FILE P. I. No. M003340, Dooly County
CSNHS-M003-00(340)
I-75 Interstate Pavement Replacement

SUBJECT APPROVED REVISED PROJECT CONCEPT REPORT

SUBJECT Revised Project Concept Report

REVISED PROJECT CONCEPT REPORT

TS-01

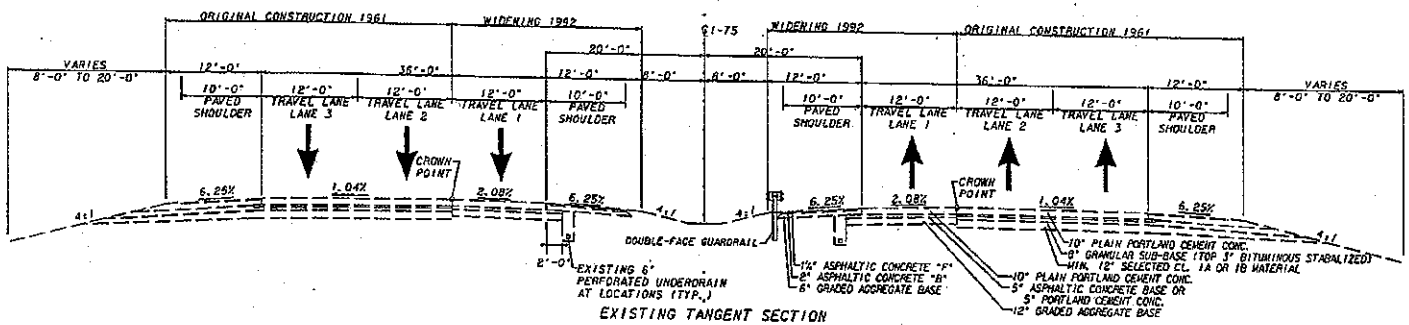
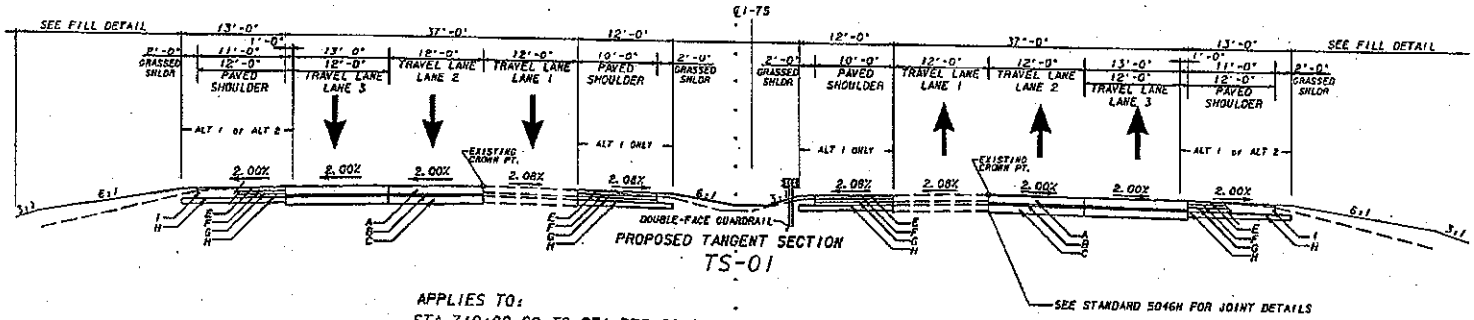
The pavement type in the previous concept was CRCP on the mainline and shoulders. The length of the project in the previous concept was 10.3 miles. This is an incorrect length.

The revised project will consist of JDCP on the mainline and HMA/RCC alternates on the outside shoulder. See typical section for structure details. The revised project length should be 9.66 miles.

* During the design process, please evaluate using a 14-foot outside lane, striped at 12 feet, rather than the proposed 13-foot lane. The extra foot of width should distribute edge stresses better and result in improved service life of the pavement.
RWF
